HISTORIC AND DESIGN REVIEW COMMISSION

HDRC CASE NO: 2023-351
ADDRESS: 3853 N ST MARYS ST
LEGAL DESCRIPTION: NCB A49 PART OF A-2, A-4, A-52 (208 AC)
ZONING: R-5, HL
CITY COUNCIL DIST.: 2
APPLICANT: James Torres/Don B. McDonald Architects
OWNER: CITY OF SAN ANTONIO
TYPE OF WORK: New construction of a 2-story restroom structure
APPLICATION RECEIVED: August 18, 2023
60-DAY REVIEW: October 17, 2023
CASE MANAGER: Rachel Rettaliata

The applicant is requesting a Certificate of Appropriateness for approval to construct a 738-square-foot, 2-story restroom structure.

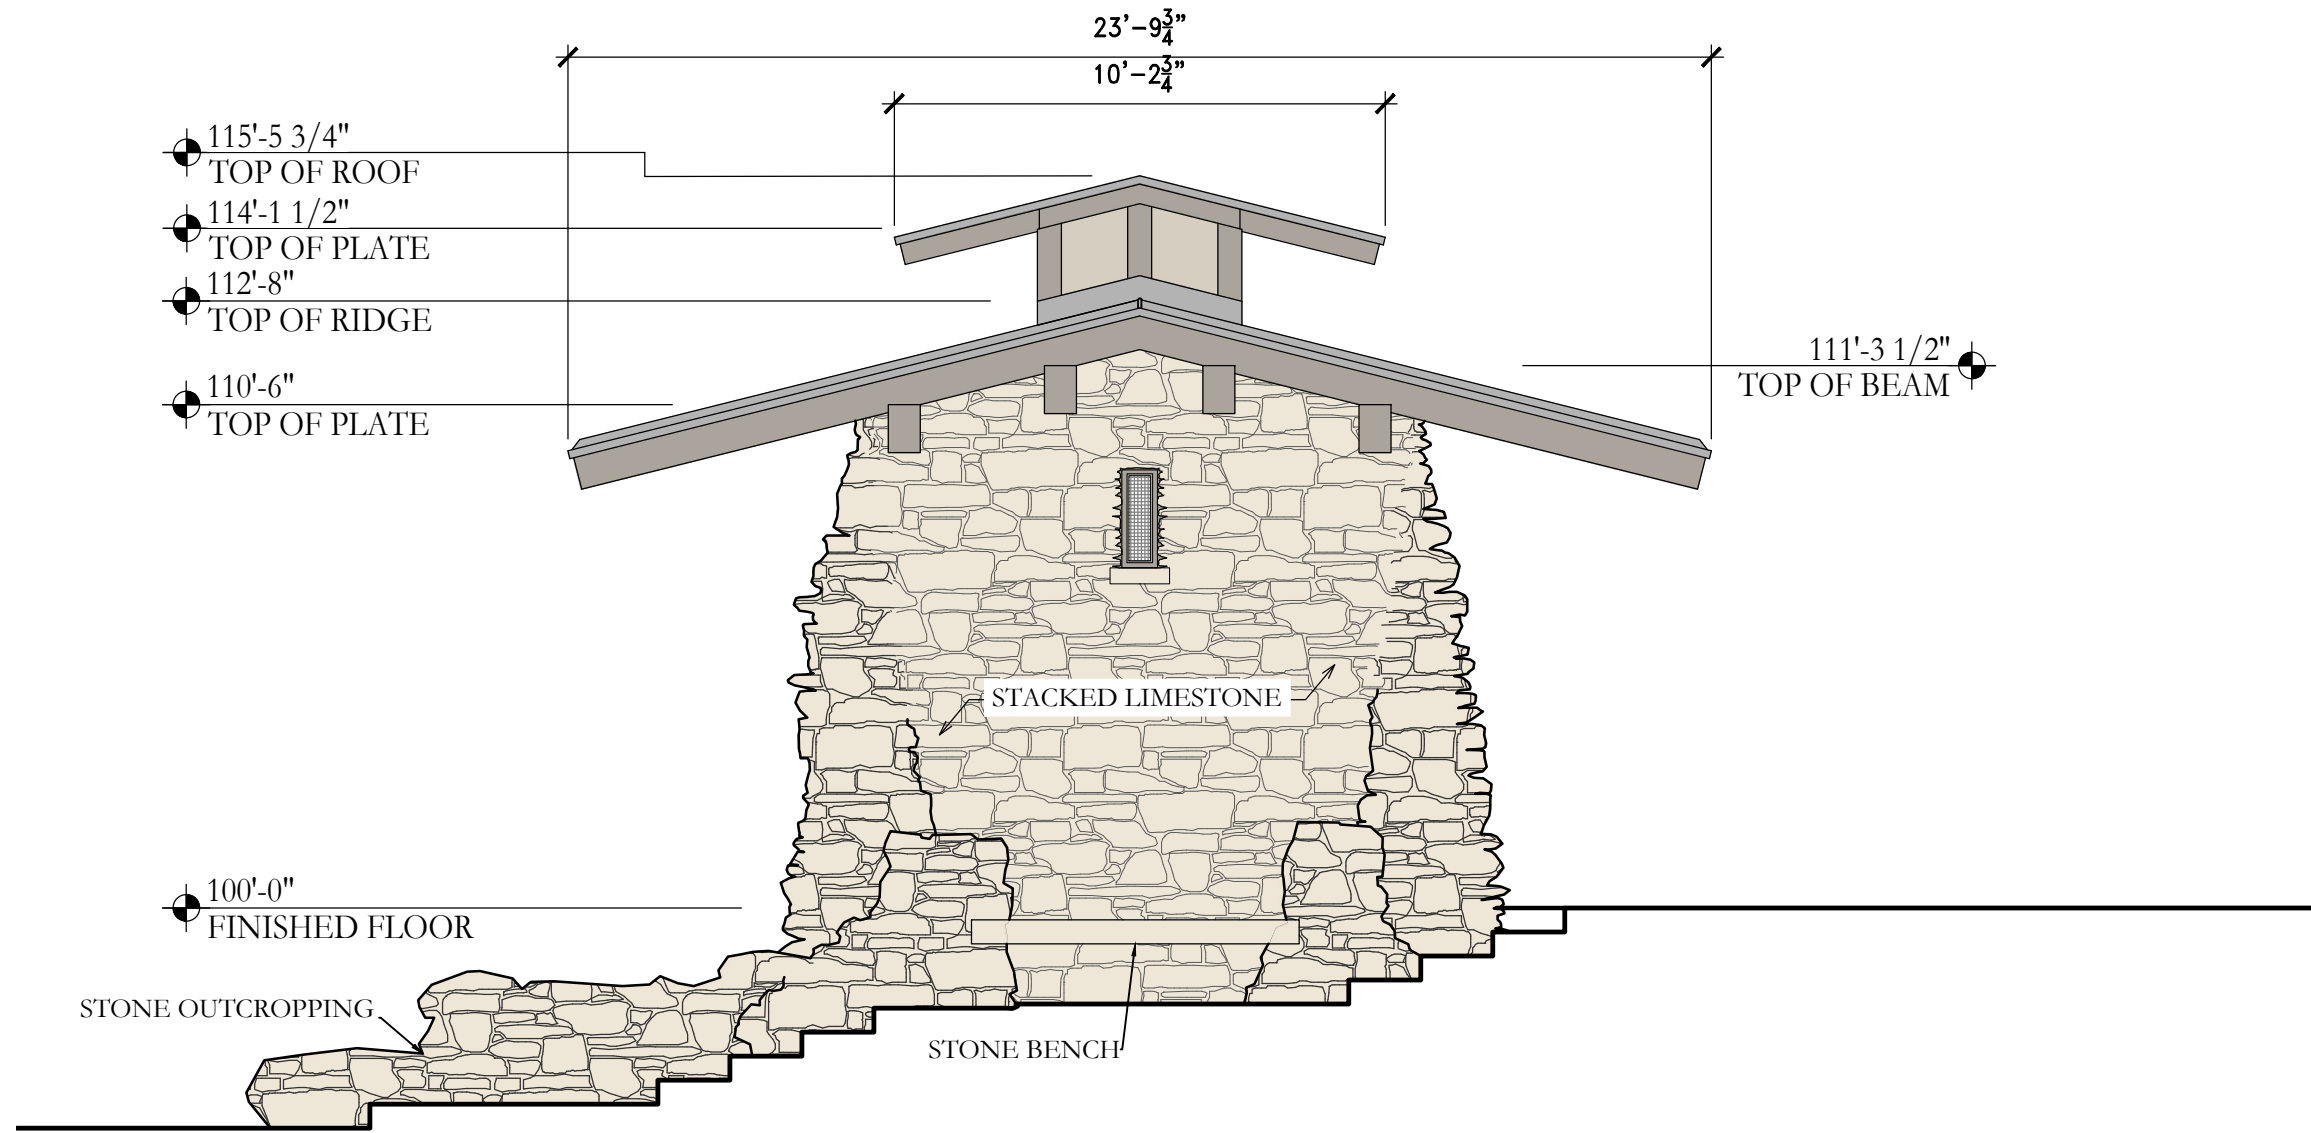
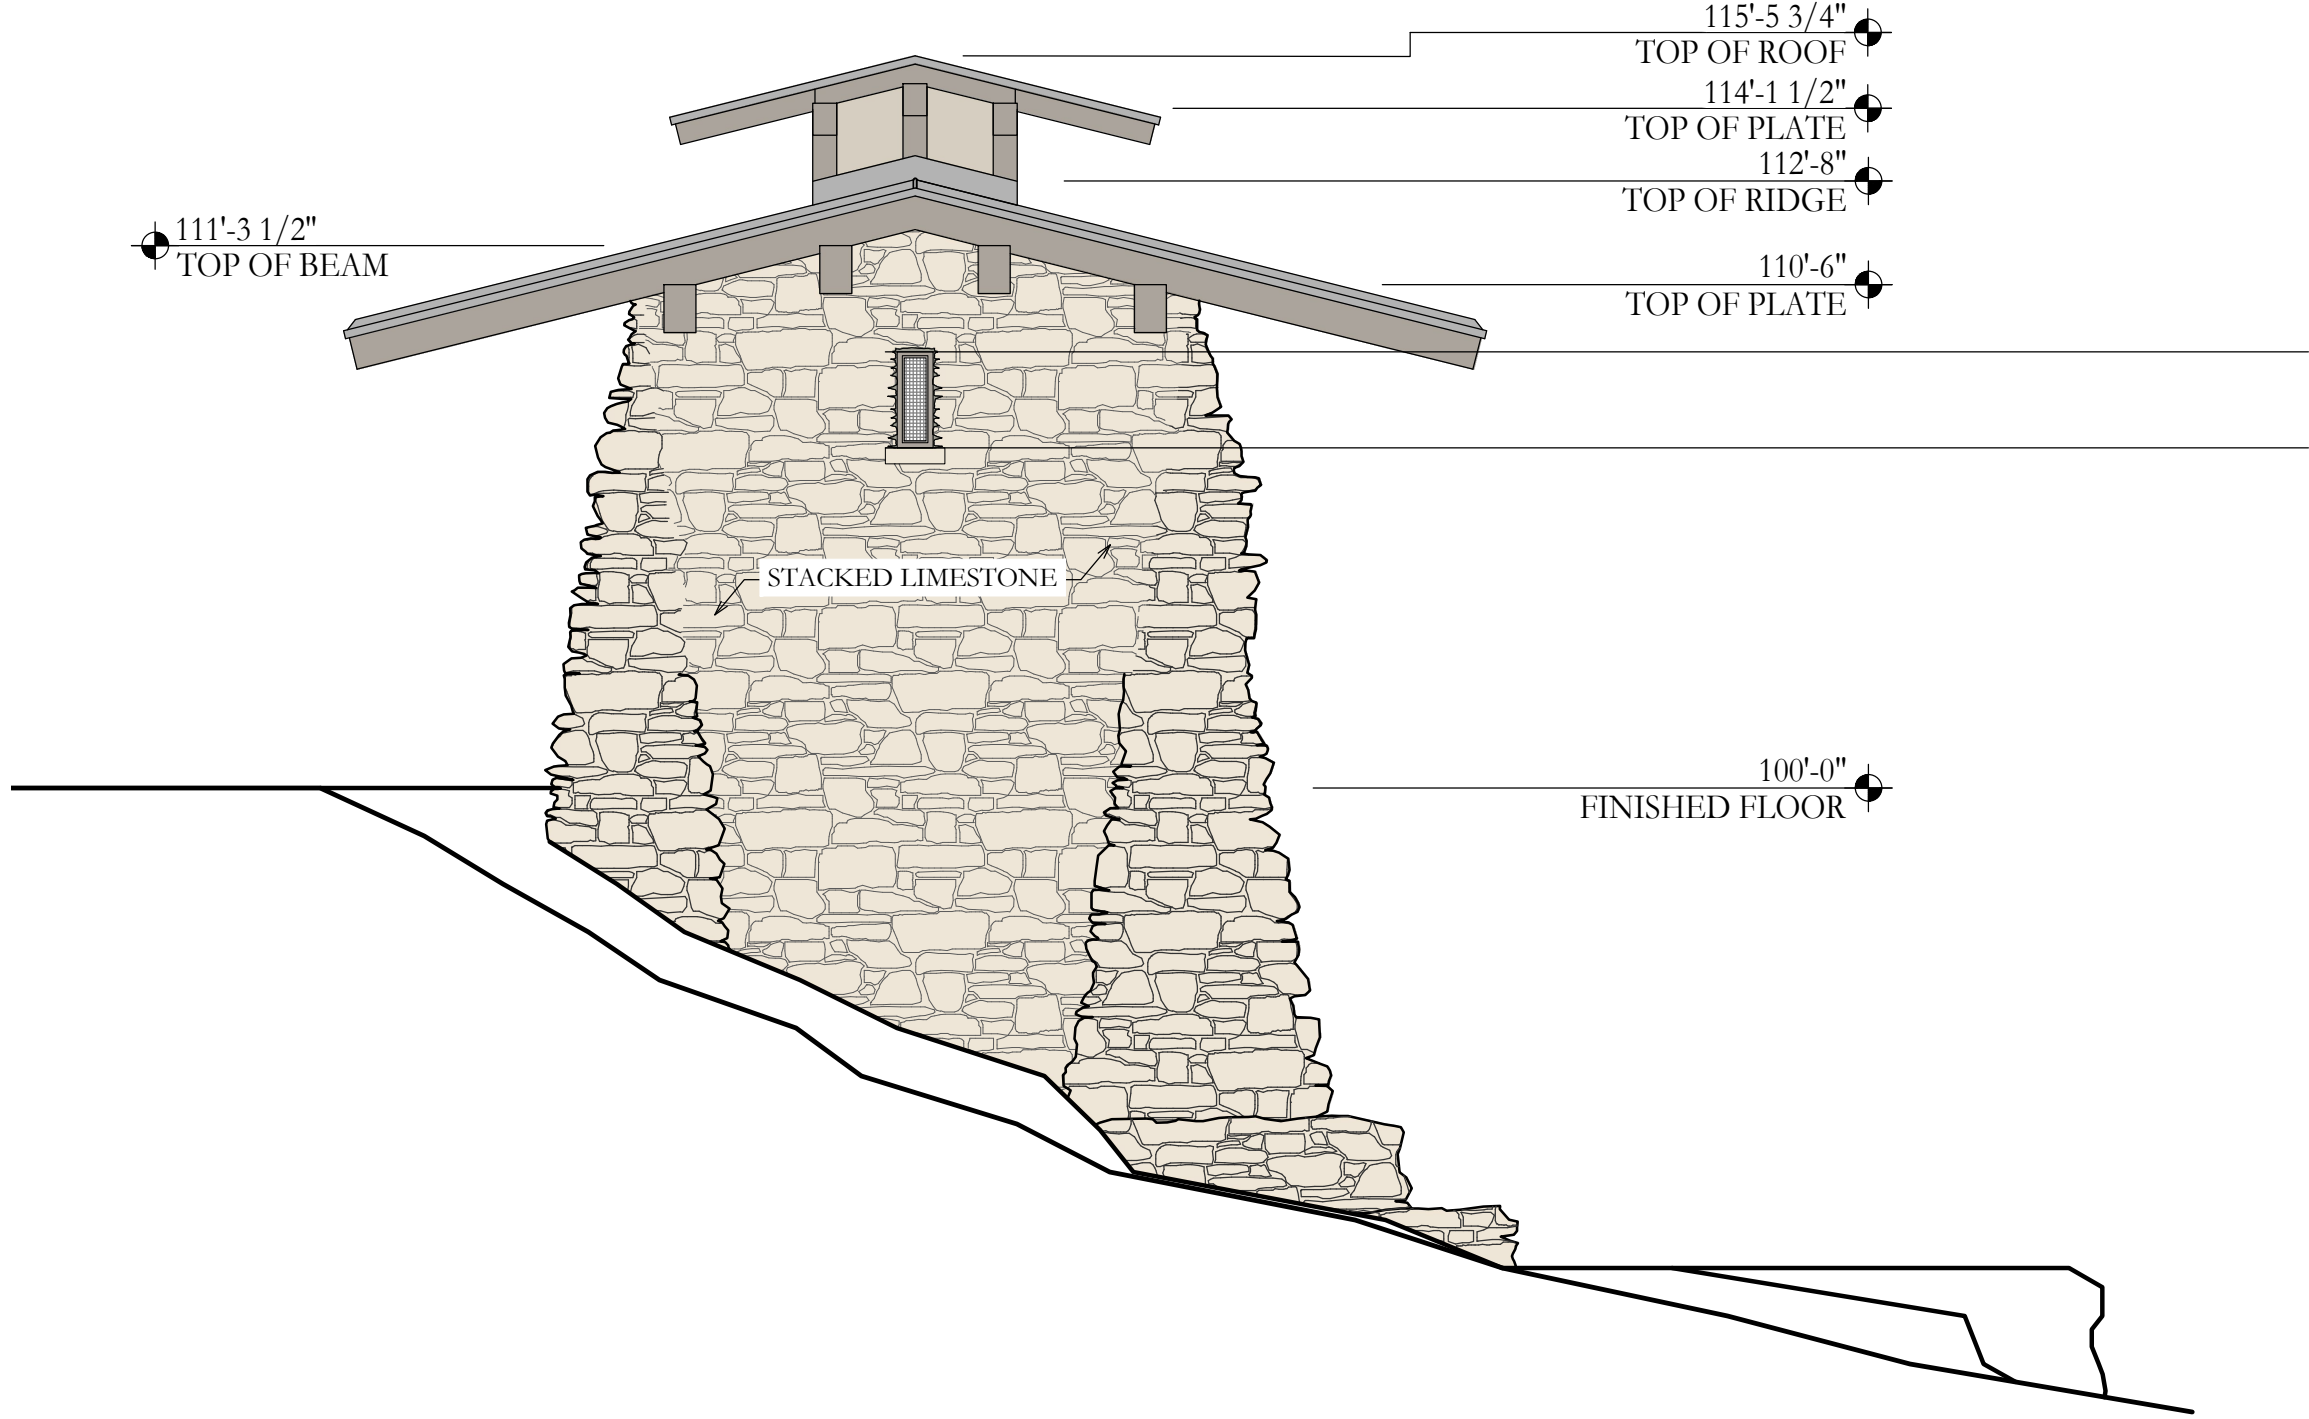
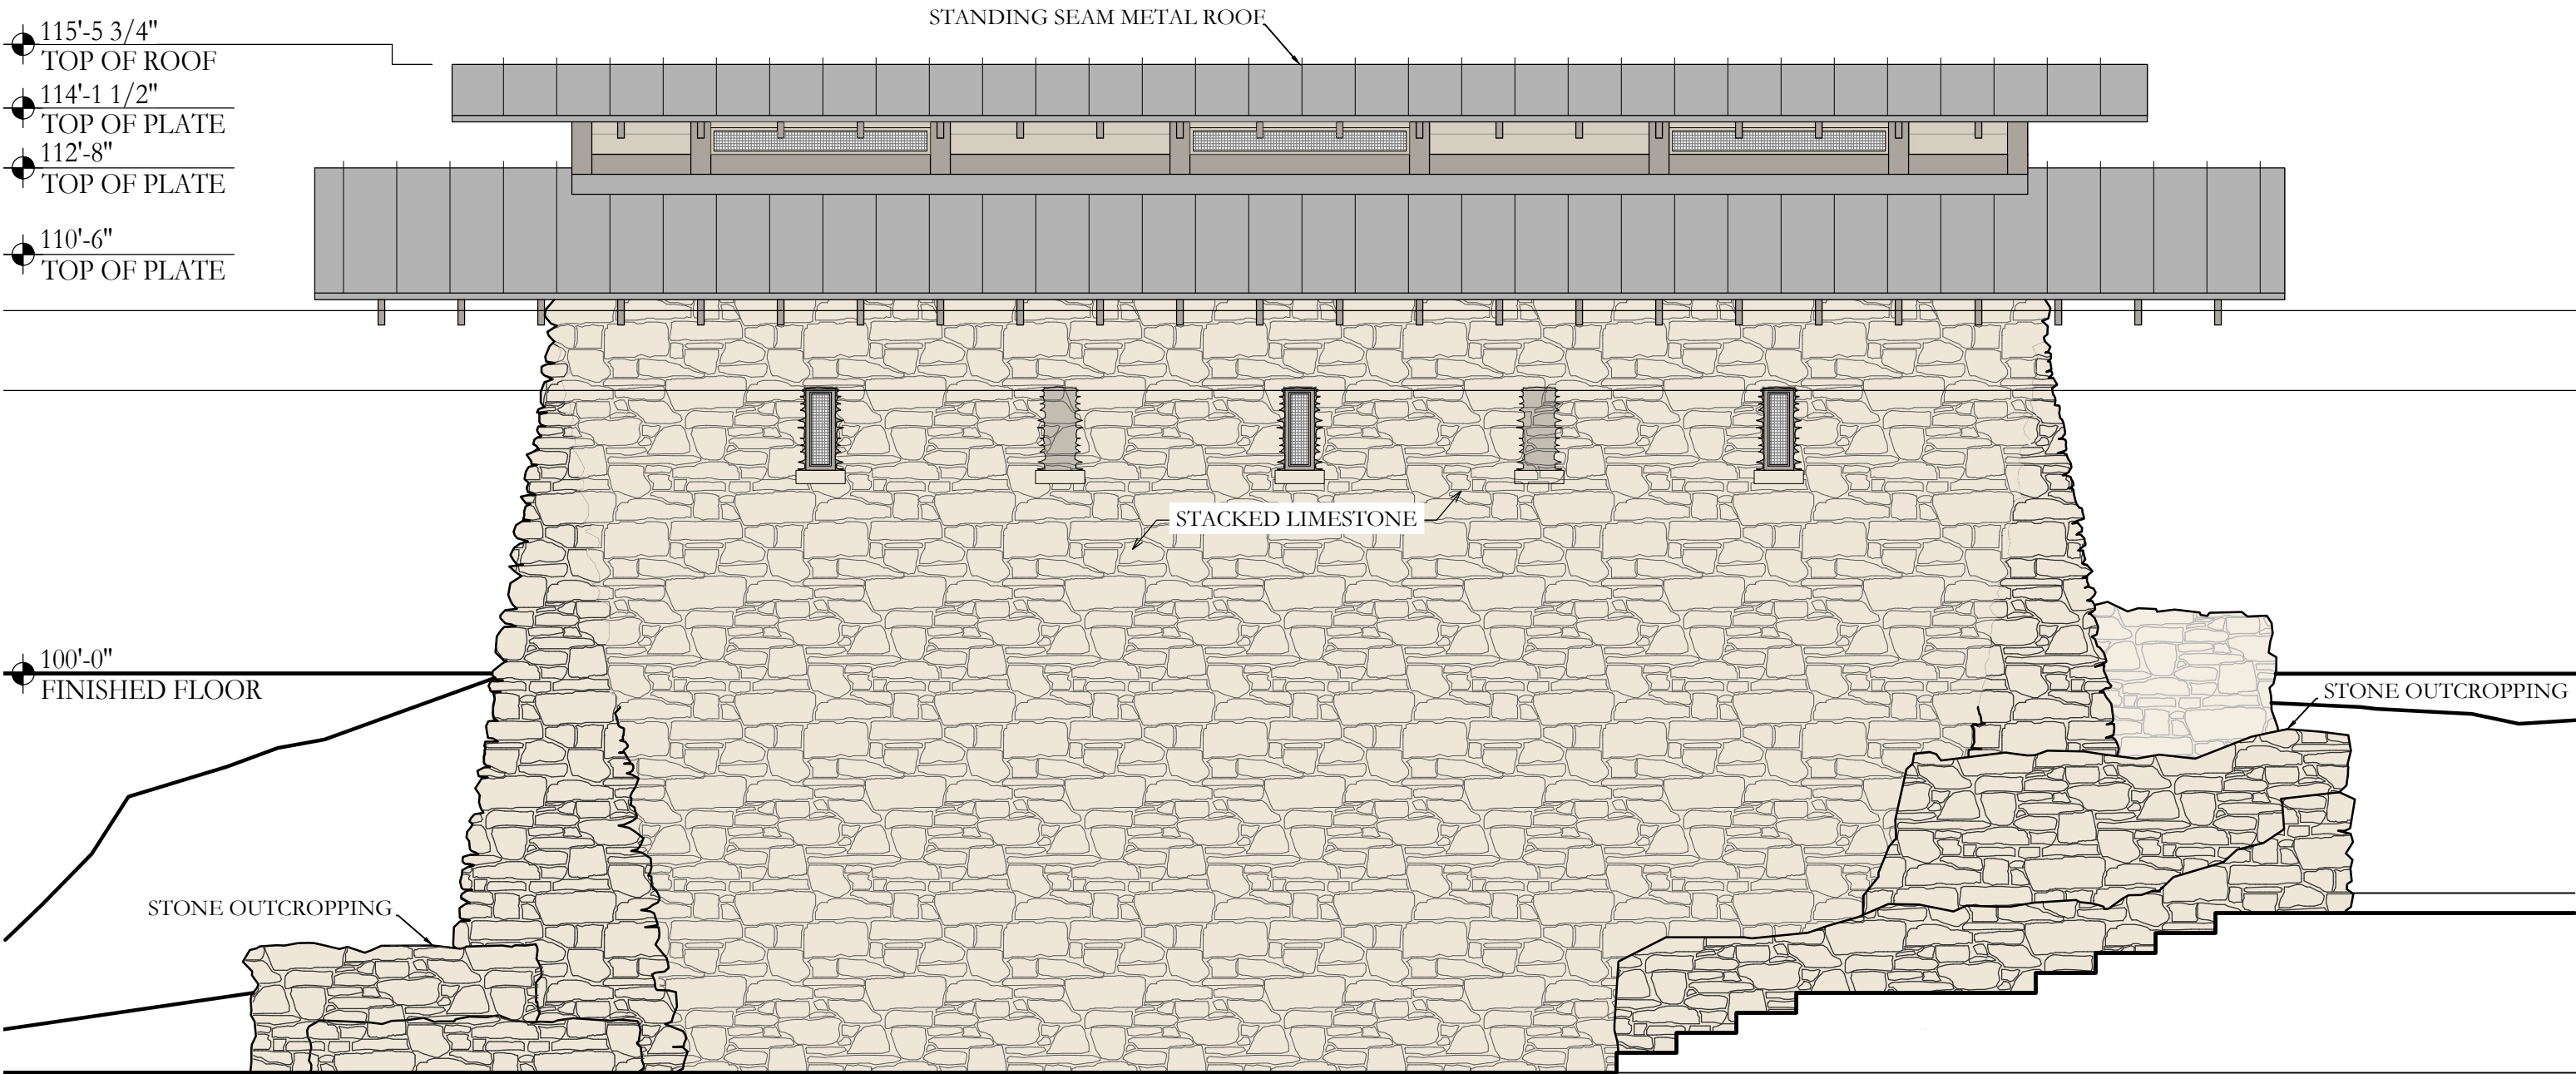
- d. ROOF FORM – The applicant has proposed to install a side gable standing seam metal roof with a row of clerestory windows and a secondary side gable standing seam metal roof. Guideline 2.B.i for New Construction states that new construction should incorporate roof forms—pitch, overhangs, and orientation—that are consistent with those predominantly found in the area. Additionally, Guideline 3.A.iv for New Construction states that new metal roofs should be constructed in a similar fashion as historic metal roofs. Staff finds the proposal consistent with the Guidelines.

- g. MATERIALS: FAÇADE – The applicant has proposed to construct the restroom facility using stacked limestone cladding to match the existing masonry typology at the Sunken Garden. The facility will additionally feature wood rafters, wood beams, and a mahogany drip edge. Guideline 3.A.i for New Construction stipulates that new construction should use materials that match in type, color, and texture traditionally found in the district and materials should not be so dissimilar as to distract from the historic interpretation of the district. For example, corrugated metal siding would not be appropriate for a new structure in a district comprised of homes with wood siding. Staff finds that proposal appropriate.

- i. That the applicant installs a standing seam metal roof featuring panels that are 18 to 21 inches wide, seams that are 1 to 2 inches high, a crimped ridge seam, and a standard galvalume finish. Panels should be smooth without striation or corrugation. Ridges are to feature a double-munch or crimped ridge configuration; no vented ridge caps or end caps are allowed. An inspection must be scheduled with OHP staff prior to the start of work to verify that the roofing material matches the approved specifications.
